Program Bulletin

CUSTOMER SATISFACTION PROGRAM

SUBJECT: Auxiliary Battery Power Not Available

MODELS: 2007-2011 Chevrolet Silverado
2007-2011 GMC Sierra
2500/3500 Series Equipped with an Auxiliary Battery (TP2)

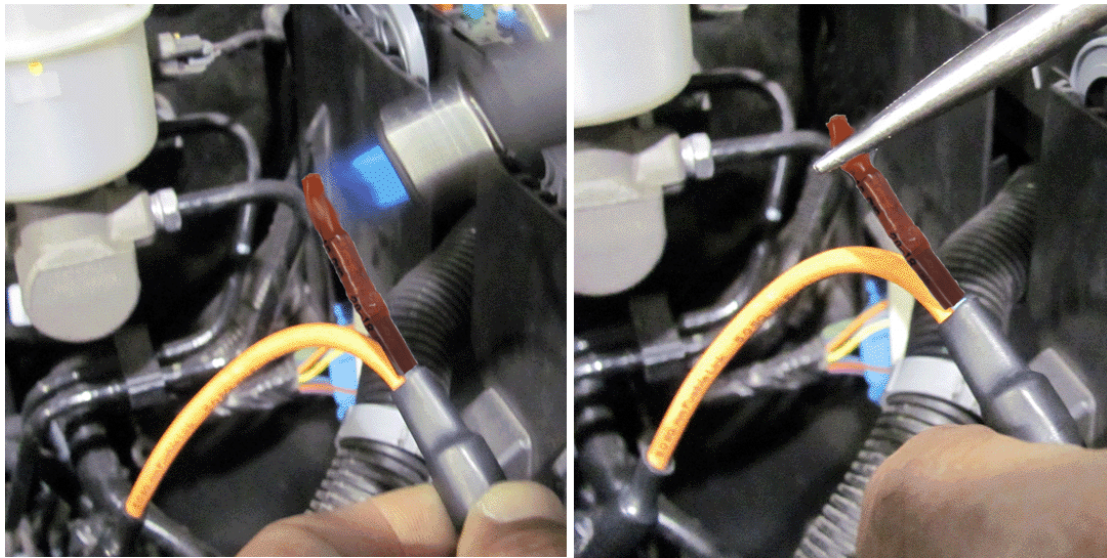
7. Cut 152 mm (6 in) off of blue wire. Measure from the terminal end of the wire. Leave approximately 25 mm (1 in) of blue wire. Refer to illustration.
8. Strip approximately 5 mm (0.20 in) insulation off of blue wire.

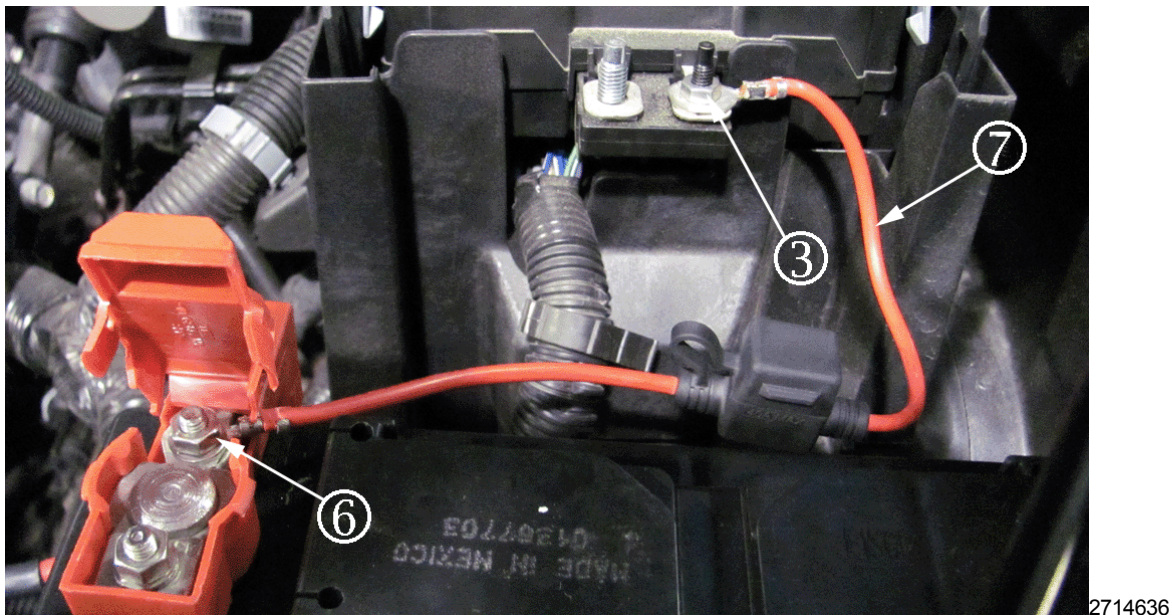
13. Install one end of the inline J-case fuse jumper (7) to the underhood electrical center/junction block stud (3) and the other end of the J-case fuse jumper (7) to the auxiliary battery stud (6).
14. Install red wire, if present, to underhood electrical center/junction block stud (3).
15. Tighten stud nuts to 10 Nm (89 lb-in).
